**DEPARTMENT OF TRANSPORTATION
STATE OF GEORGIA**

FILE: STP-0006-00(276) Gwinnett County OFFICE: Atlanta, Georgia
P.I. No. 0006276
DATE: April 21, 2008

SUBJECT: Revised Project Concept Report

REVISED PROJECT CONCEPT REPORT

Project Location Map

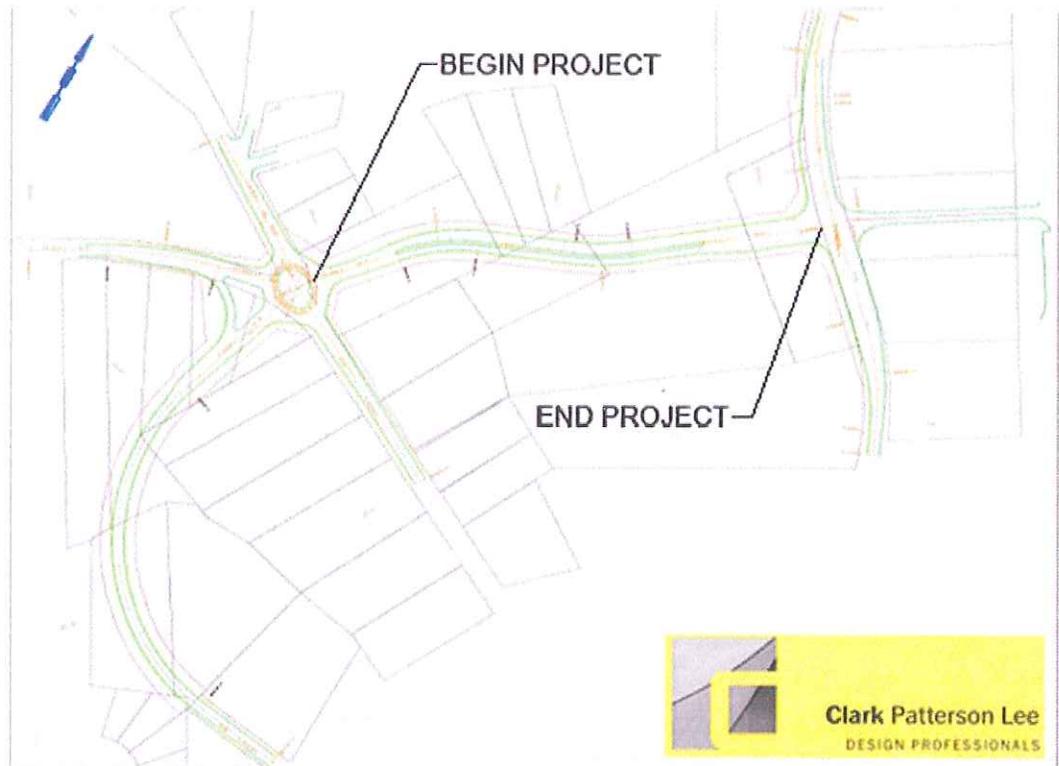
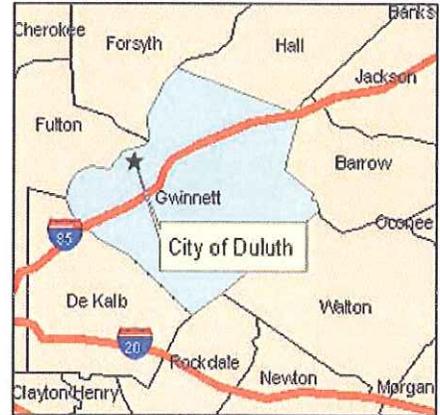
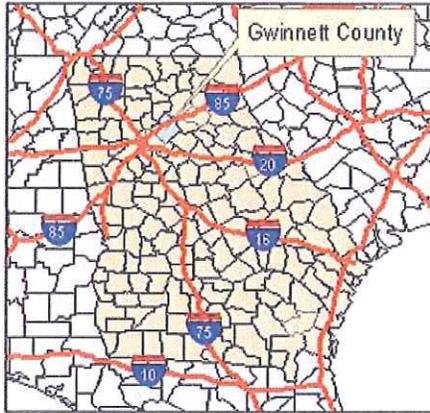
1. With regard to changes to the project termini, the beginning of the project has been changed from the end of the existing Ridgeway Road to the intersection of McClure Bridge Road and Lawrenceville Road. The section of Ridgeway Road and the proposal roundabout included in the original concept will be constructed with local funds and therefore is being deleted from the federally funded project.
2. No changes are planned on the proposed typical section.
3. With regard to changes in right-of-way limits, the limits of right of way have been decreased due to the removal of the Ridgeway Road section.
4. No changes are planned concerning the proposed alignment.
5. No changes are planned for access control.
6. No changes are planned for controlling criteria.
